Rezoning Transportation Analysis

Petition Number: 2020-007

General Location Identifier: Tax ID 11123334

Date	Description
03-24-2020	First Review

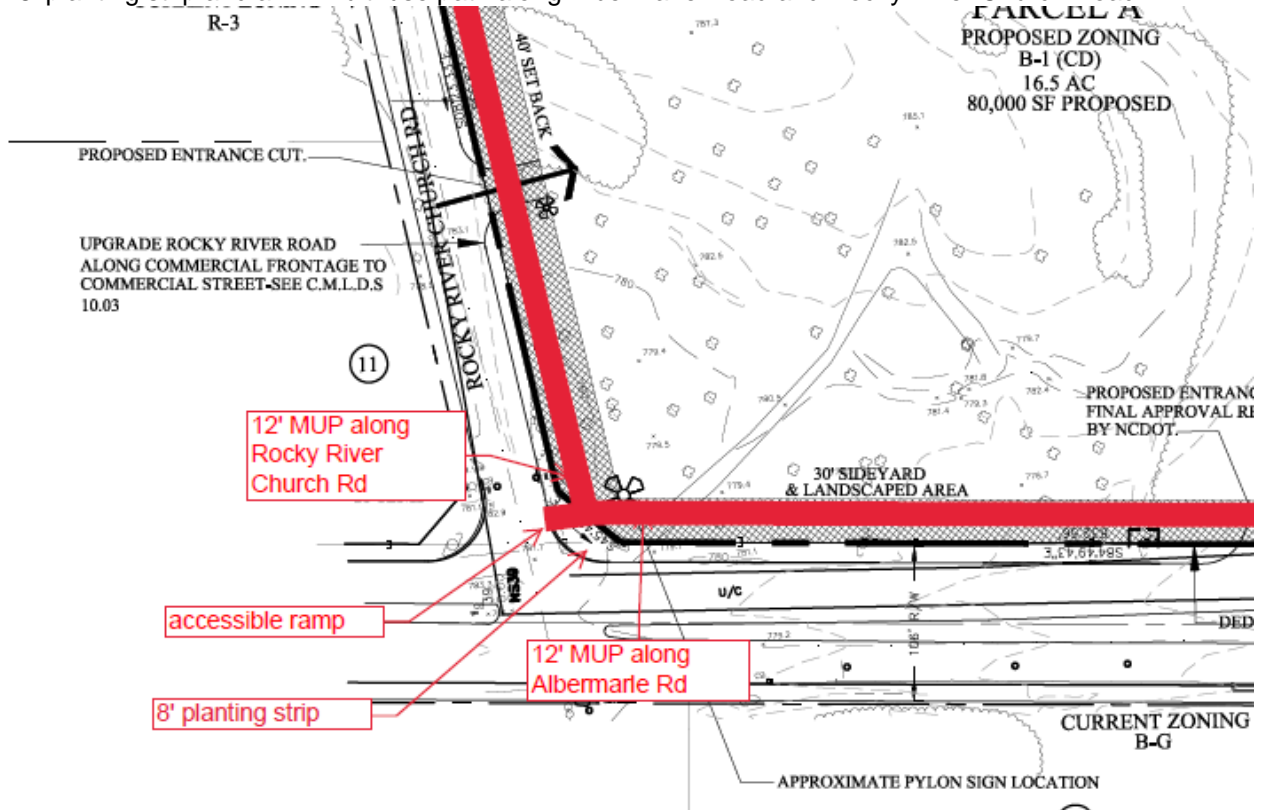
3. The petitioner should revise the site plan and conditional note(s) to commit to dedicate a minimum of 50 feet of right-of-way from the Albermarle Road centerline, per Chapter 12 of the Zoning Ordinance requirements for a Charlotte Regional Transportation Planning Organization (CRTPO) classified major thoroughfare. The site plan should label and dimension the right-of-way from the road centerline.
